# AP1000 DESIGN CERTIFICATION REVIEW

## Response to Request For Additional Information

RAI Number: 100.002

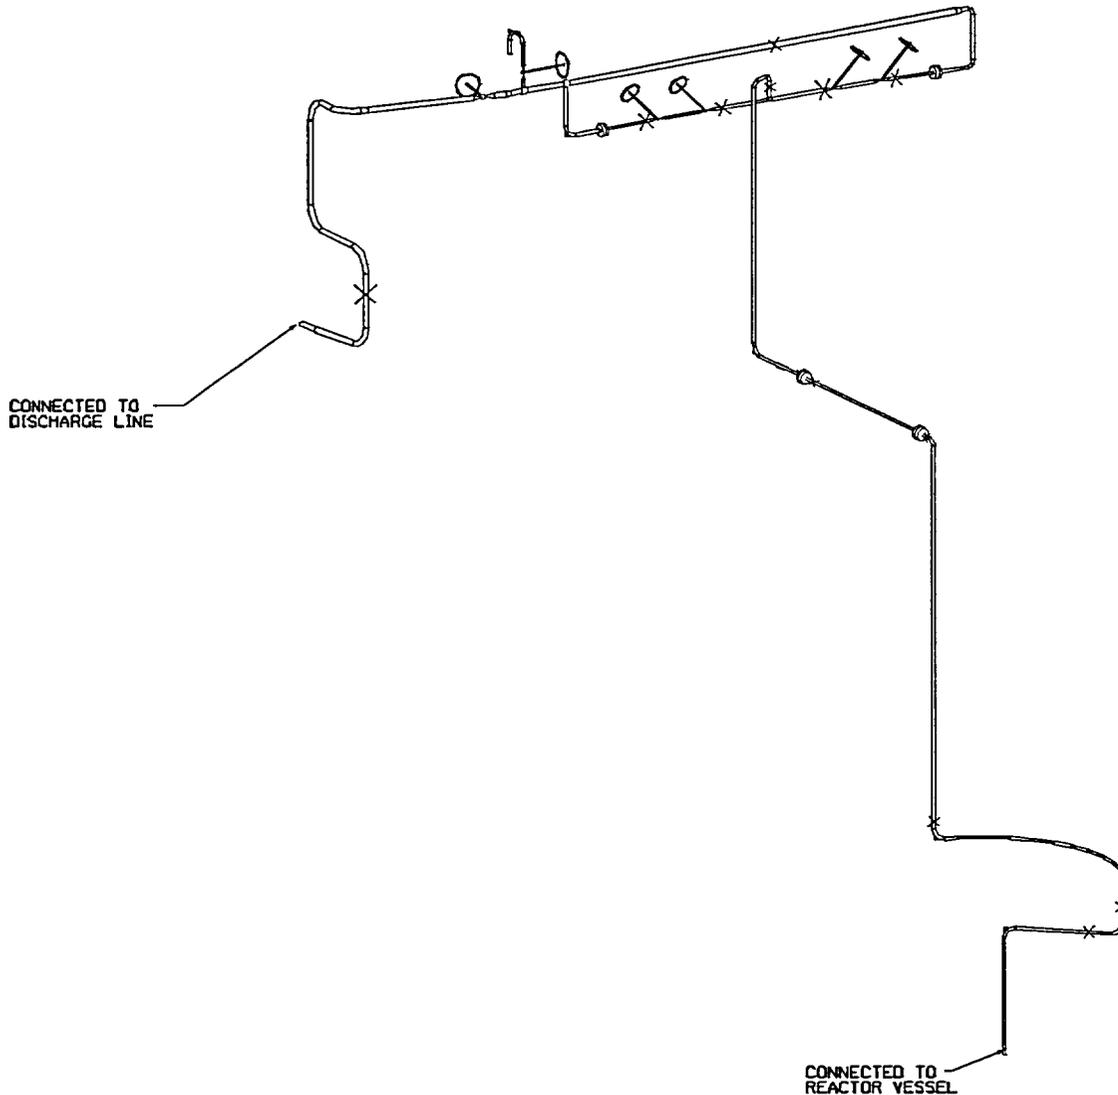
Hydrodynamic loads could be significant for piping systems with fast opening and closing valves. The reactor vessel head vent system (RVHVS) piping has been identified as a system susceptible to such large hydraulic transient loadings. Experience from operating nuclear power plants indicates that thermal hydraulic loads could be very severe for certain operating modes if the piping layout does not take this aspect into careful consideration. Please provide assurance that the AP1000 plant specific RVHVS piping configuration can be designed to withstand the transient thrust forces caused by the valve opening without performing the thermal hydraulic and structural dynamic analyses at this time. To demonstrate the conceptual design and facilitate the staff's review, it is suggested that a sketch be provided along with the response.

The reactor vessel head vent piping systems (RVHVS) utilized in conventional Westinghouse PWRs consist of two basic layout configuration types. One layout configuration utilizes a modified CRDM housing that is capped at the top and a one inch pipe welded to it. The flow path from which the RPV venting would occur is through the modified CRDM (approximately equivalent to a three inch pipe), into the one inch head vent piping containing the one inch valves, and discharging into either the containment or the discharge header of the Pressurizer Safety and Relief Valve System. This layout configuration can result in significant thermal hydraulic loads (upwards of 30 to 40 kips) due to RPV through the modified CRDM and into the one inch piping.

The second layout configuration type utilizes a one inch vent pipe welded to a dedicated one-inch penetration nozzle in the head of the RPV. For this layout configuration, the flow path for the venting is directly from the RPV into the one inch piping, through the one inch valves, and into either the containment or the PSARV discharge piping. This layout configuration significantly reduces the magnitude of the thermal hydraulic loads resulting from the venting of the RPV.

For both the AP600 and AP1000 RVHVS, the piping layout was developed such that the thermal hydraulic loads are kept to a minimum. The second layout configuration type as described above is utilized with the one inch piping welded directly to the RPV head. In addition, length of piping between elbows is also kept to a minimum in order to reduce the effect of these thermal hydraulic loadings. Long straight sections of piping (i.e. greater than 20 feet) are not used.
